UNITED STATES  
NUCLEAR REGULATORY COMMISSION  
WASHINGTON, D. C. 20555

SUBJECT: Documents received from DOE, for delivery to you

Comments on NUREG/CR-3081, BNL-NUREG-51630, Vol. 6  
"Review of Waste Package Verification Tests"; semiannual  
report covering the period October 1984 - March 1985.

# NEVADA NUCLEAR WASTE ISOLATION PROJECT TECHNICAL CONTRACTORS

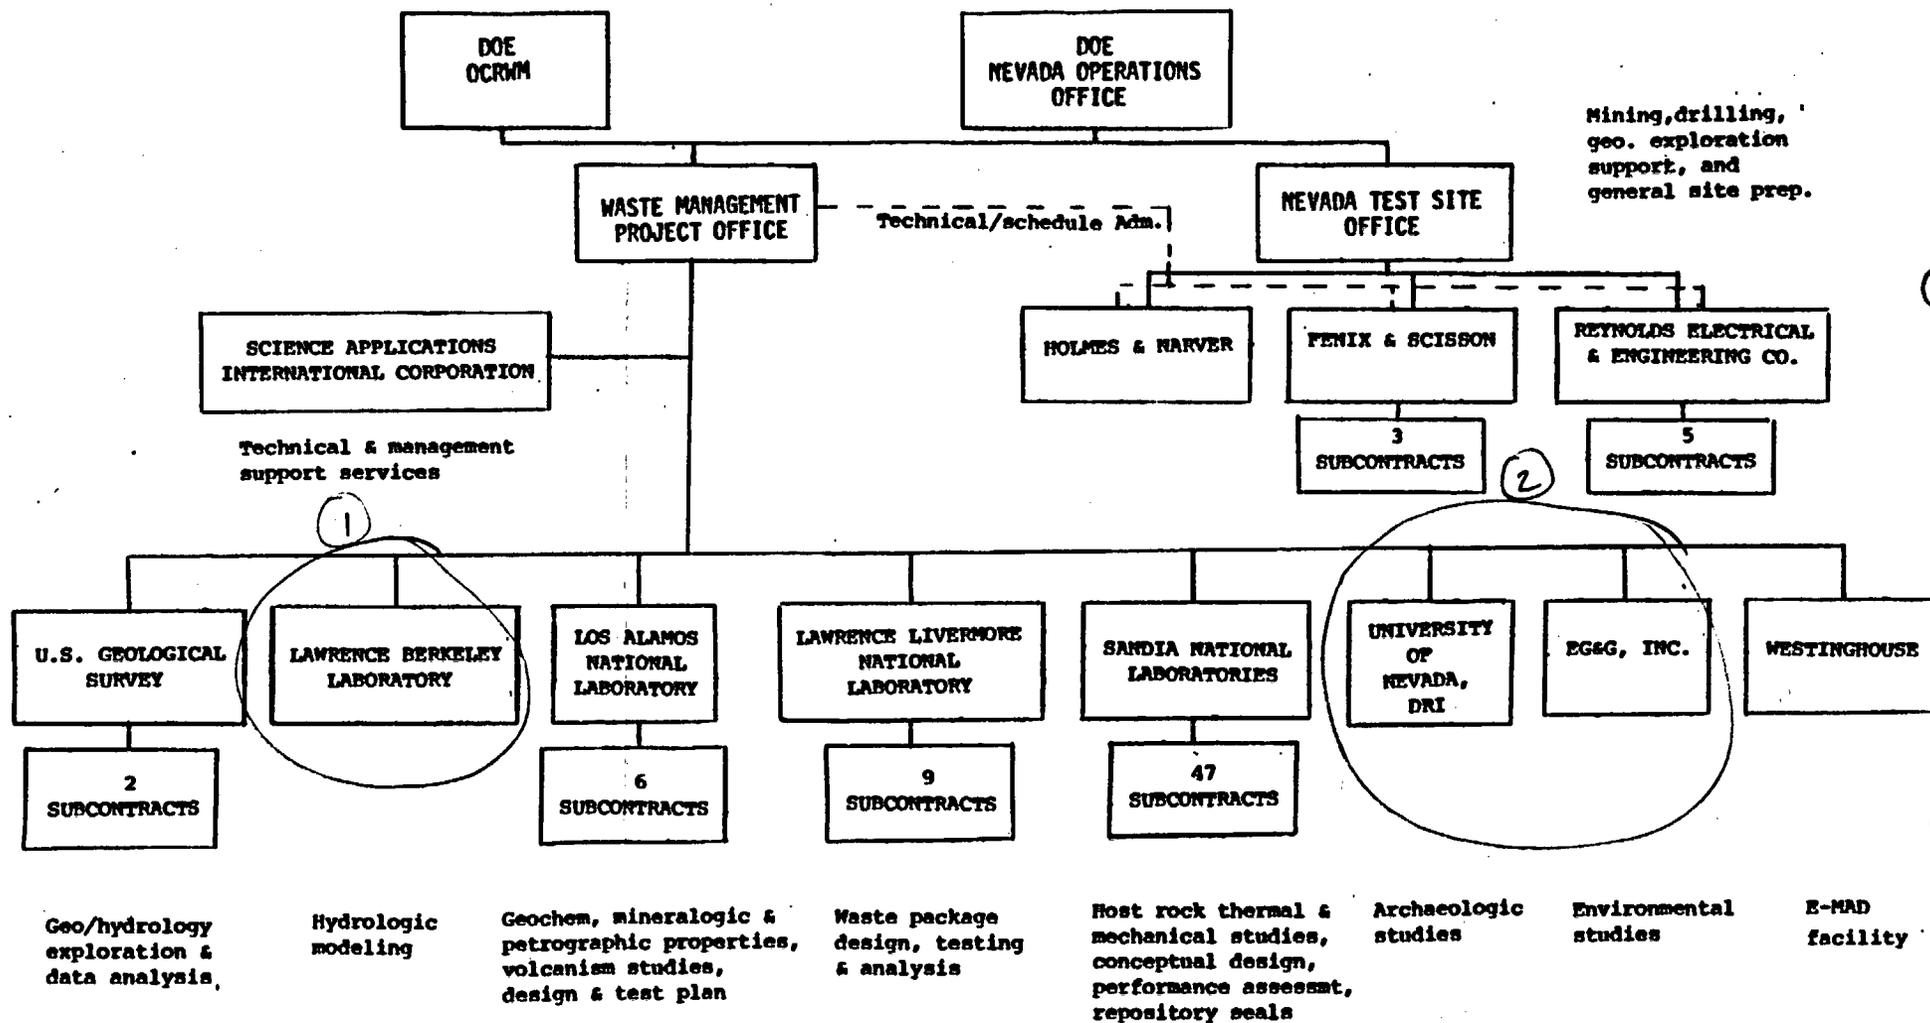
I have two comments on the organization chart. (1) Lawrence Berkeley Laboratory is not directly in the structure as shown. Apparently LBL has been subcontracted by USGS for hydrologic modeling support and also ~~may~~ provide support to DOE/HQ. (2) DRI and EG+G provide the archaeological and environmental studies for the entire Nevada Test Site, not just the Yucca Mountain area. As such, WMPO does not directly interface with those organization in contractual matters.
